# ADDENDUM No. 1

## RFP No. 25-01

### 2025 Miscellaneous Utility Projects

DRAWING No.  
2024006-24

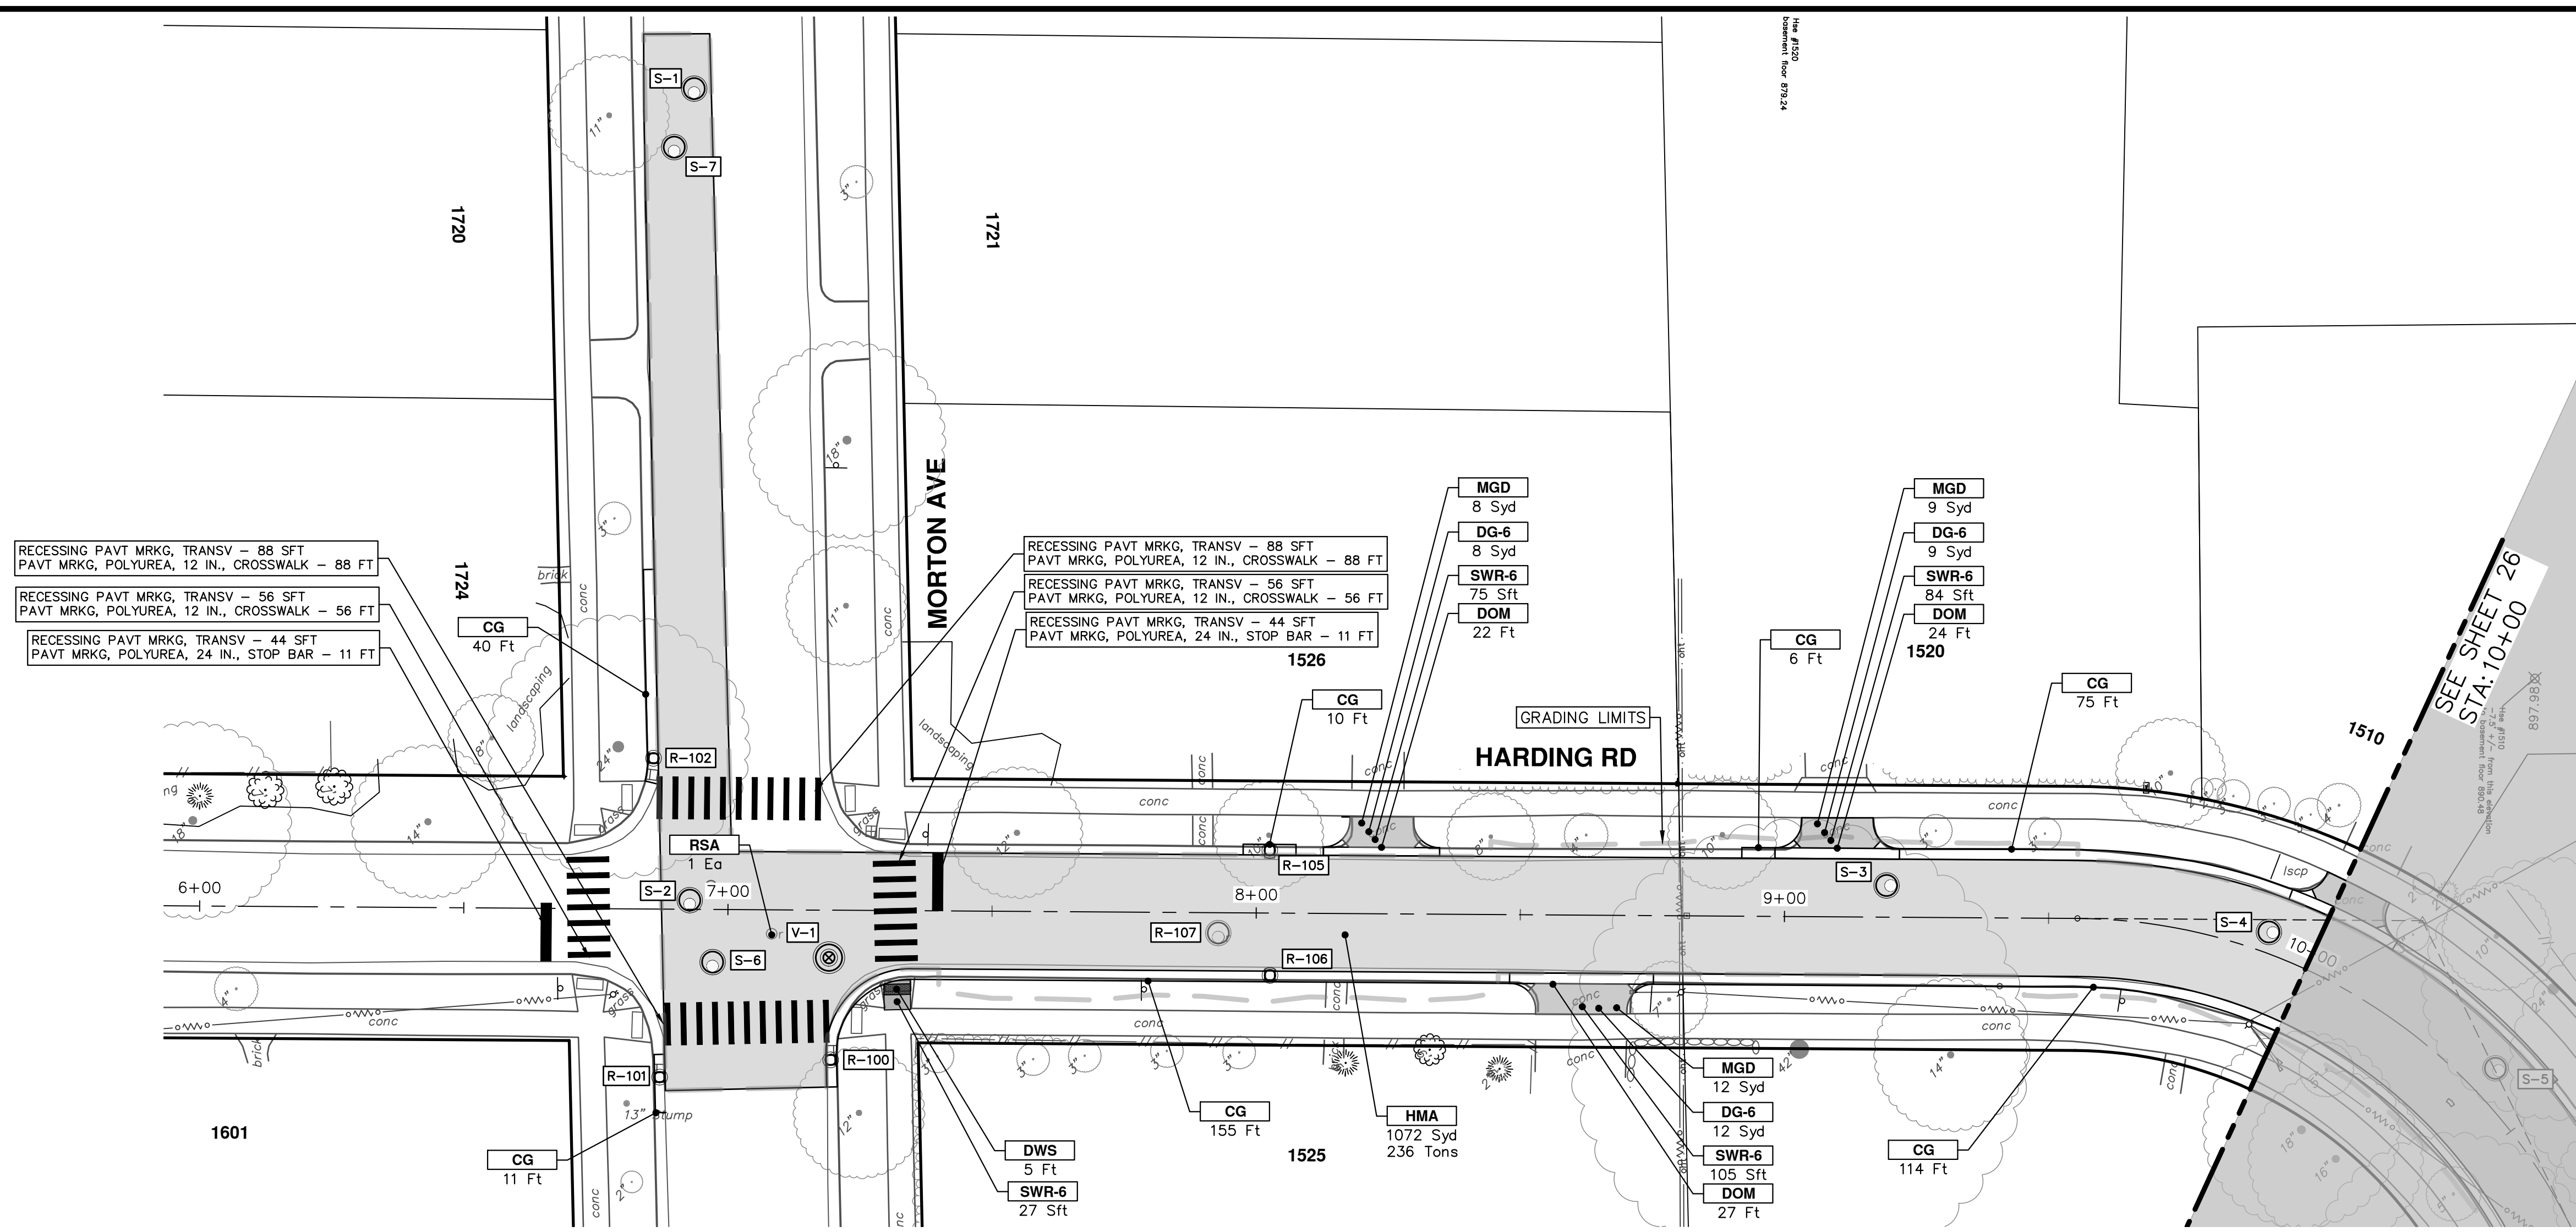
Sheet 25: Hatching removed from profile (CAD error)

DRAWING No. 2024006-48

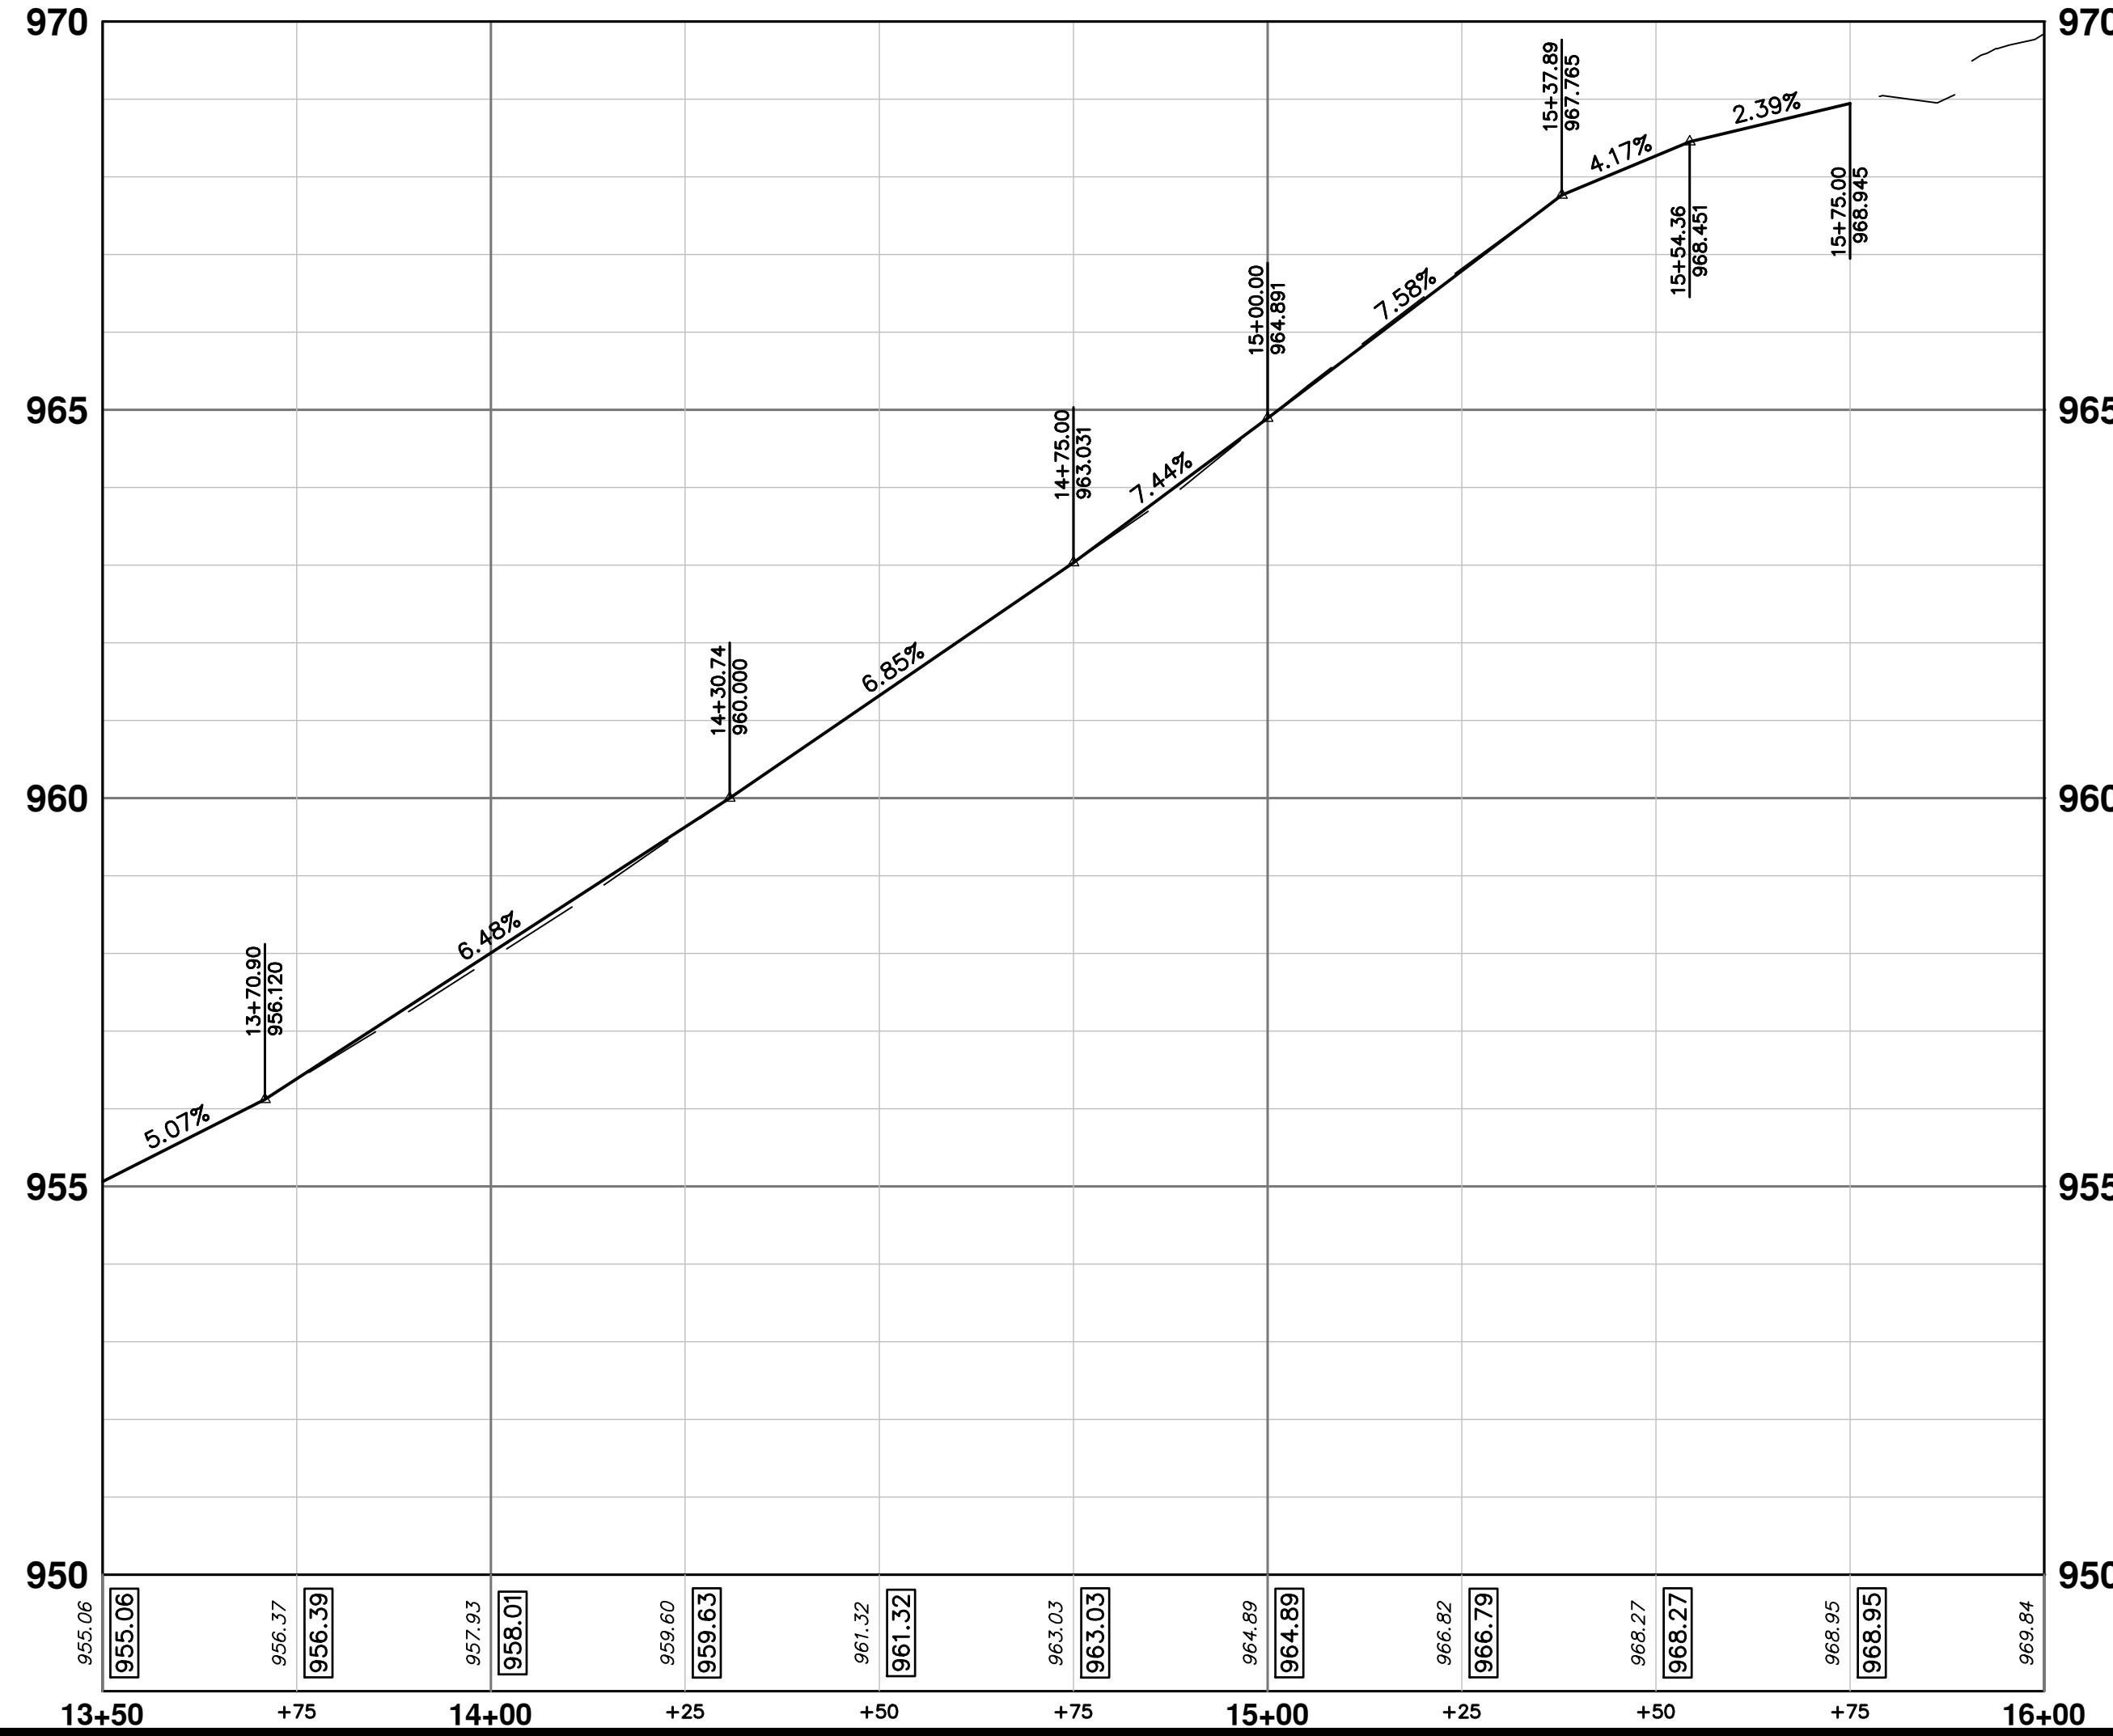
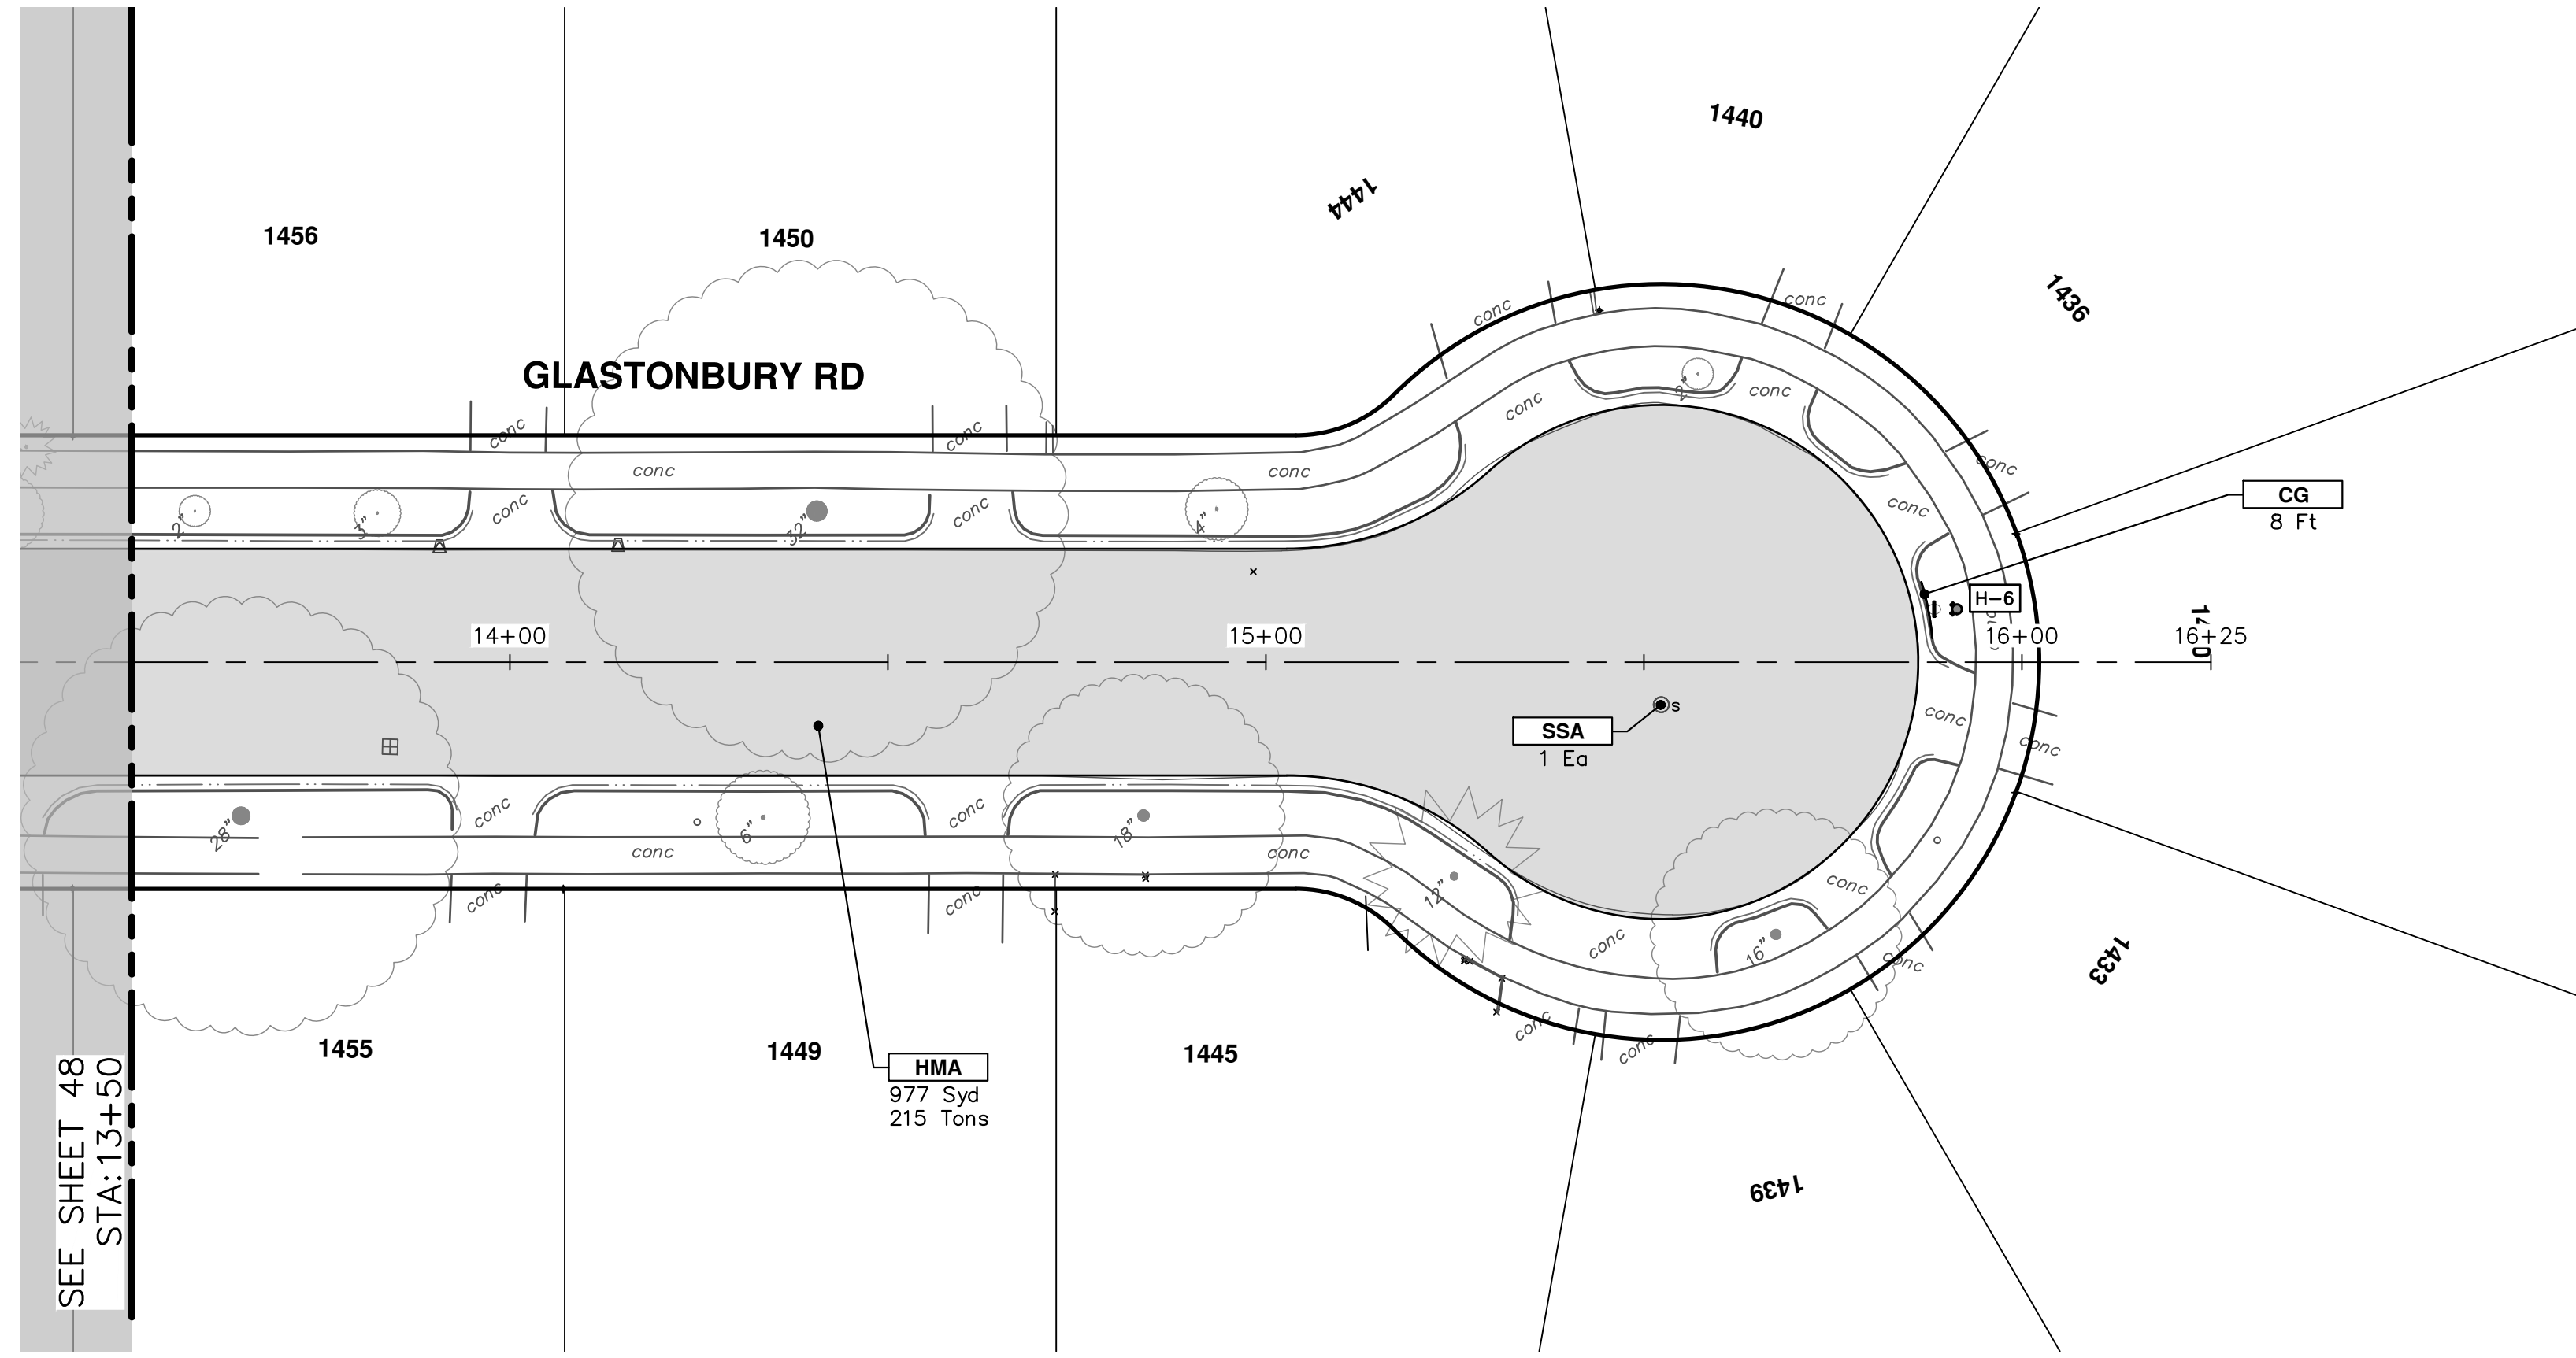
- Question 21: Due to the depth of the of the proposed sanitary sewer on Morton, and the existing sanitary manhole 71-69776, S-2 will need to be moved farther away to facilitate construction.

Answer 21: A trench box should be used to install the new sanitary main as close to the existing main as possible. The sewer may be moved in the field slightly if necessary for construction. The intent was that 71-69776 be removed and a temporary sewer be installed in its place to accommodate S-2.
